UNITED STATES PATENT AND TRADEMARK OFFICE

Office Action Summary

10/573,180

TANAKA, TOMIJI

FIG. 1

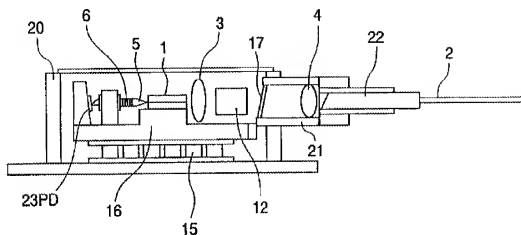
With respect to claims 1 and 11, Kimura discloses in Fig. 1a laser system, comprising: a base plate/surface plate 20; a heat sink (bottom plate of the enclosure); that is connected to the base plate and that is nearly perpendicular thereto; a heat generation device or a heat absorption device 15 that is connected to the heat sink and that is nearly perpendicular to the base plate; and a laser section that is connected to the heat generation device or the heat absorption device and that is nearly perpendicular to the base plate, one surface of the heat generation device or the heat absorption device being connected to the laser section, the other surface of the heat generation device or the heat absorption device being connected to the heat sink, wherein the laser section has a semiconductor laser device 1, a lens 5, a grating 6, and a support member 16, the semiconductor laser device, the lens, and the grating composing an external cavity type semiconductor laser, the support member supporting the external cavity type semiconductor laser, wherein the laser section is connected to the heat generation device or the heat absorption

device connected to the heat sink by the support member, and wherein the external cavity type semiconductor laser is covered by the support member and a lid 17 that has heat resistance.

With respect to claims 3 and 13, Kimura discloses a space between the laser section and the base plate with a predetermined height (see the Fig. 1).

With respect to claims 4, 7, 14 and 17, Kimura discloses the claimed invention except for explicitly teaching the specific distance between the base plate and the laser section; however, it would have been obvious to the one having ordinary skill in the art at the time the invention was made to provide a distance of at least 10 mm between the laser section and the base plate because the distance between the grating support and the base plate is obviously larger than 10 mm.

With respect to claims 5-6, 8, 15-16, and 18, there is air between the base plate and the photodiode holder. Air is considered as a good heat insulation member. Therefore the laser system include a space between the base plate and the laser section, because the photodiode holder is located between the base plate and the laser section.
